Assessment of Camden Growth Areas
Contributions Plan - Lowes Creek
Maryland

Camden Council

Draft Report

September 2023

Figure 4.3 Distribution of basin construction unit costs by basin type (\$ / m²)

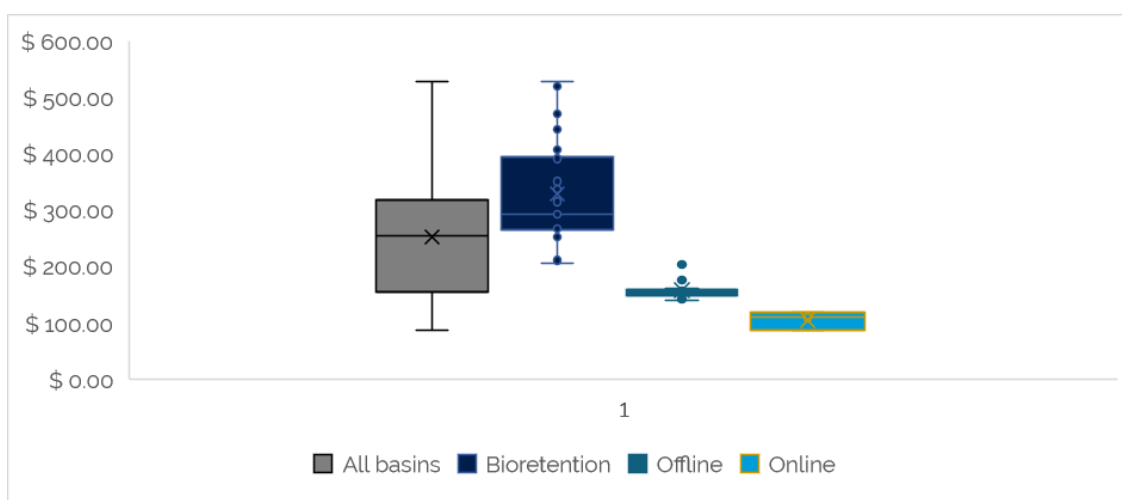
The unit costs of the 16 online and offline detention basins are between \$88 to 204 per m². The weighted average unit cost of the detention basins within the plan is \$133 / m².

While two offline detention basins fall outside the reference costs range (offline basin 2 and 20) they contain additional filter media. The remaining basin unit costs fall within the reference price range or close to the upper bound of this range.^b The online and offline detention basins are the largest component of the stormwater works (approximately 68% of total stormwater works costs within the plan). We consider the detention basin costs included within the plan are reasonable.

Figure 4.4 Bioretention basin construction costs in the LCM CP

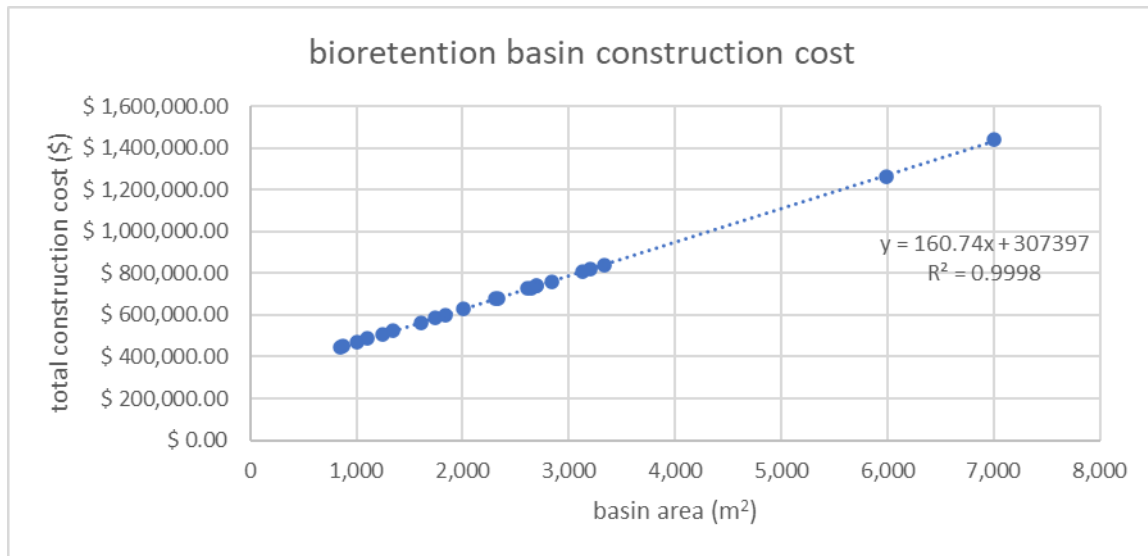
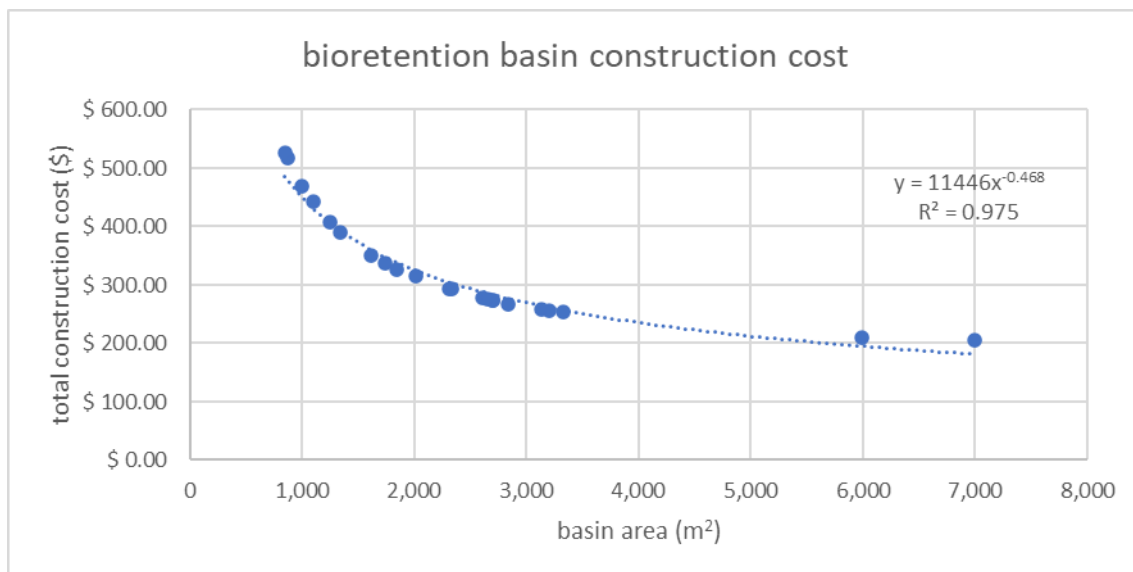
The total construction costs of bioretention basins increase linearly with basin area (Figure 4.4). The unit rate cost reduces with basin area. The bioretention basin unit rate costs range between \$206 to \$527 / m². The weighted average unit cost of bioretention basins within the plan is \$285 / m² (\$2021).

Of the bioretention basins proposed in the plan, 8 have a unit rate cost above \$317 / m² and 14 are below. All the basins with a higher unit rate are smaller than 1840m² and combined have a total construction cost of approximately \$4.6 million (equivalent to 7% of the stormwater works costs).

The median and weighted average unit rates of the bioretention basins included within the plan both fall below this rate at \$293 / m² and \$285 / m² respectively despite some key scope differences across all bioretention basins.^c

Figure 4.12 Council Land Value Index compared to Valuer General information

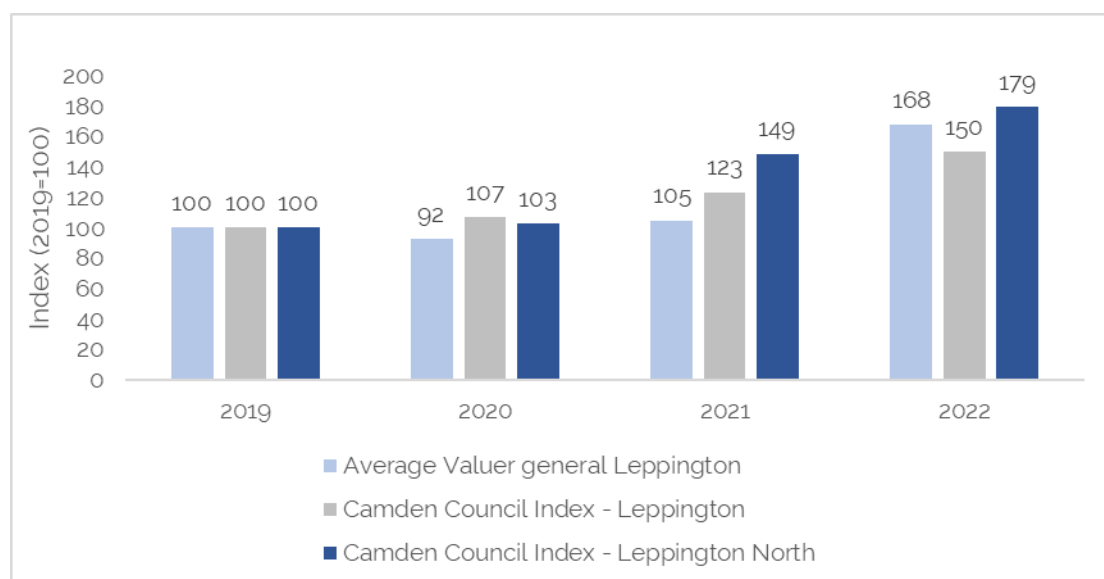
We have compared the existing Camden LVIs to the implied percentage change in land values for the Leppington region using Valuer General data. Using a base period of 2019, the Camden LVIs imply a higher rate of growth in land value for 2020 and 2021 compared to Valuer General data. This gap is closed somewhat in 2022 (Figure 4.12).

We consider that the LVI should only be applied to the land contribution rates based on costs of land not yet acquired. It is unreasonable to apply the LVI to the land contributions rates based on costs of land already acquired, since the value of those acquisitions have already been settled. Any land costs already incurred should be inflated by the ABS issued Consumer Price Index, consistent with the regulation. As the LCM CP is new, no land has yet been acquired. A future review of the plan should ensure that two land contributions are created to ensure the LVI is only applied to contribution rates based on land not yet acquired.
